PRELIMINARY SAFETY EVALUATION REPORT

TRANSNUCLEAR, INC.

STANDARDIZED NUHOMS® HORIZONTAL MODULAR STORAGE

AMENDMENT NO. 13

Figure 4.1 69BTH DSC Boundary Temperatures along Top of DSC Derived from Results of STAR-CD model of 32PTH1 in HSM-H

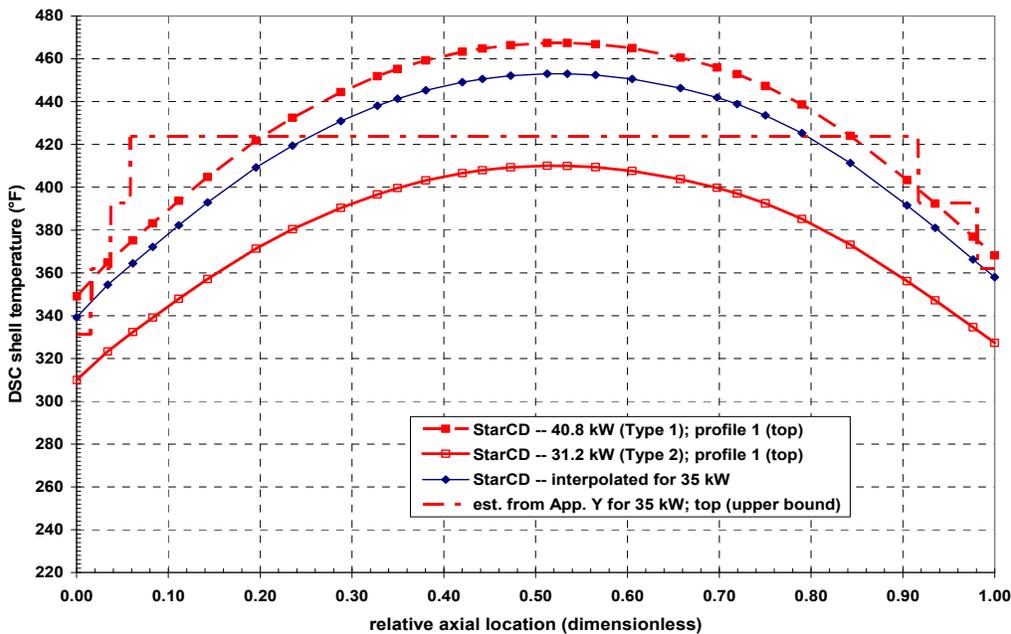
The staff performed confirmatory evaluations with a detailed COBRA-SFS model of the 69BTH DSC, using DSC surface boundary temperatures obtained from confirmatory evaluations of the 32PTH1 in the HSM-H using STAR-CD (previously developed for the review of the aforementioned Appendix U). The shell temperatures along the upper surface of the DSC, as

reported in Appendix Y of the FSAR for the 69BTH in the HSM-H are compared in Figure 4.1 to the DSC shell temperatures at the corresponding location obtained with the STAR-CD model of the 32PTH1 (at 40 kW) in the HSM-H. Similar plots are shown in Figures 4.2 and 4.3 for the temperature profiles along the side and bottom of the surface of the horizontal DSC within the HSM-H. This comparison shows that the temperature profiles used in the applicant's analyses are somewhat flattened axially, and so do not capture the axial peak temperatures on the DSC shell, but have a more conservative radial distribution, with higher temperatures on the sides and bottom of the DSC shell. Based on this comparison, the staff concluded that the surface temperatures of the 69BTH DSC with decay heat of 35 kW are effectively bounded by the DSC temperatures reported for the 32PTH1 DSC with decay heat of 40.8 kW. Similarly, the DSC temperatures of the 37PTH DSC with decay heat of 30 kW are bounded by the surface temperatures reported for the 32PTH1 DSC with decay heat of 31.2 kW. For these decay heat loads, ambient temperatures, and the HSM-H configuration, the staff determined that the thermal analyses of the 32PTH1 DSC in the HSM-H can be used to bound the thermal analyses of the 69BTH DSC and the 37PTH DSC for storage conditions in the HSM-H.

Figure 4.2 Temperature Profile Line from Top to Bottom of 69BTH DSC in Horizontal Storage

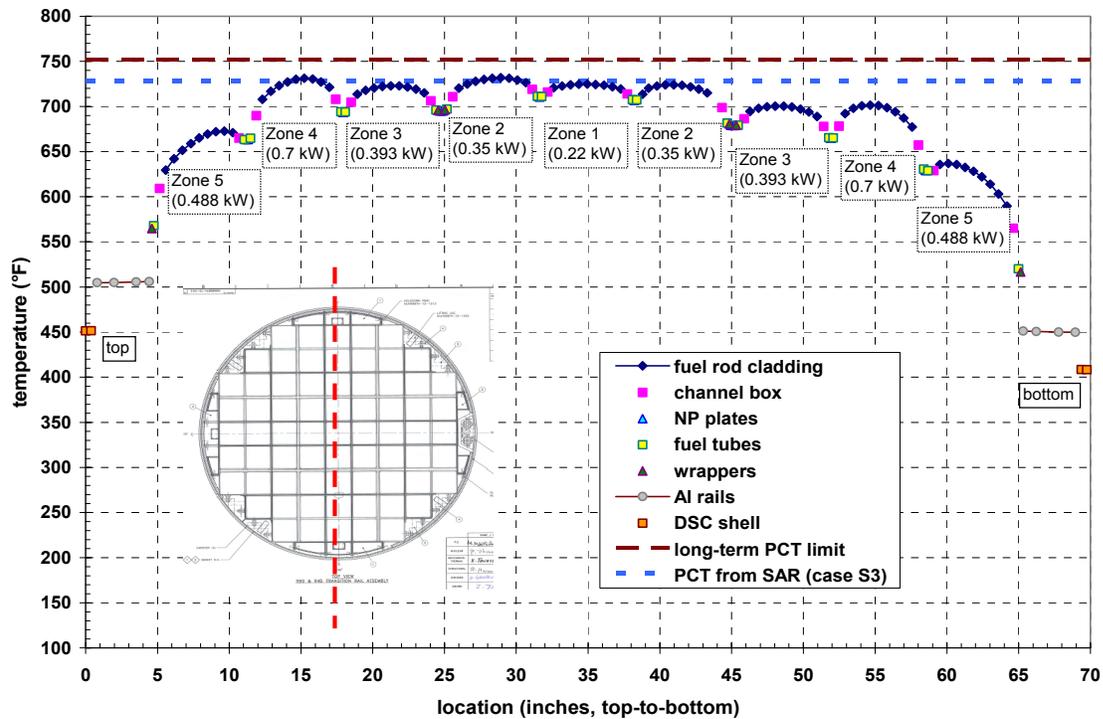
The component temperatures (including fuel rod cladding) along the line from top to bottom of 69BTH DSC through the location of peak clad temperature, determined in the staff's confirmatory evaluation are displayed in Figure 4.2. The calculated PCT within the 69BTH for each HLZC at maximum decay heat load is displayed in Table 4.20. Based on these results, the staff has confirmed that the 69BTH DSC provides adequate heat removal capacity under storage conditions.

Figure 4.3 Summary of Thermal Analysis Cases S3, S4, S5, T6, T7, T9, T12, and T13 for 69BTH DSC and 32PTH1 DSC under Storage and Transfer Conditions

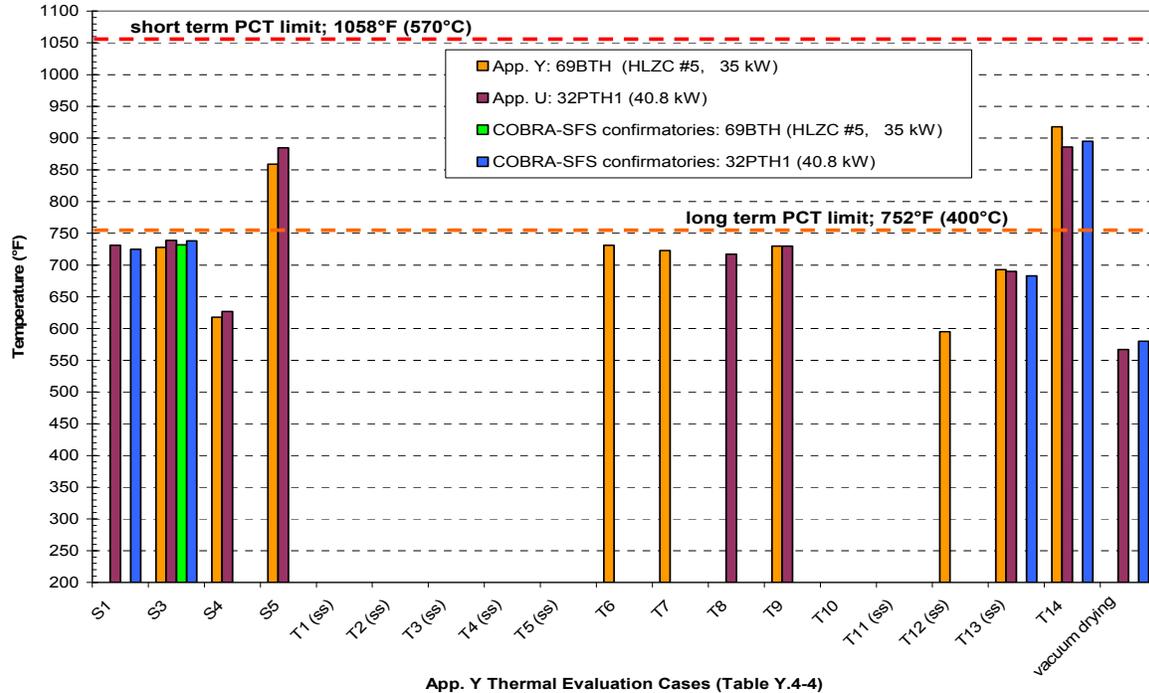
Figure 4.3 displays a summary of the results of the applicant’s thermal analysis of cases S3, S4, S5, T6, T7, T9, T12, and T13 for the 69BTH DSC and S1, S3, S4, S5, T8, T9, T13, and T14 for the 32PTH1 DSC, as well as the staff’s confirmatory evaluation of cases S3 for the 69BTH DSC and S1, S3, T13, and T14 for the 32PTH1 DSC. Based on the PCTs predicted from the applicant’s analysis, and the staff’s confirmatory evaluation of the 69BTH DSC and comparison with the PCTs calculated from the 32PTH1 DSC, the staff confirmed that the PCTs of 69BTH DSC are either bounded by the PCTs of 32PTH1 or below the temperature limits of 400°C (752°F) for normal storage and transfer conditions and 570°C (1058°F) for off-normal and accidental storage and transfer conditions. The staff confirmed that the PCTs for the bounding heat load cases of S1, S3, and S5 for normal, off-normal, and accidental storage and T9, T13, and T14 for normal, off-normal, and accidental transfer meet the required temperature limits, as shown in Figures 4.2 and 4.3.
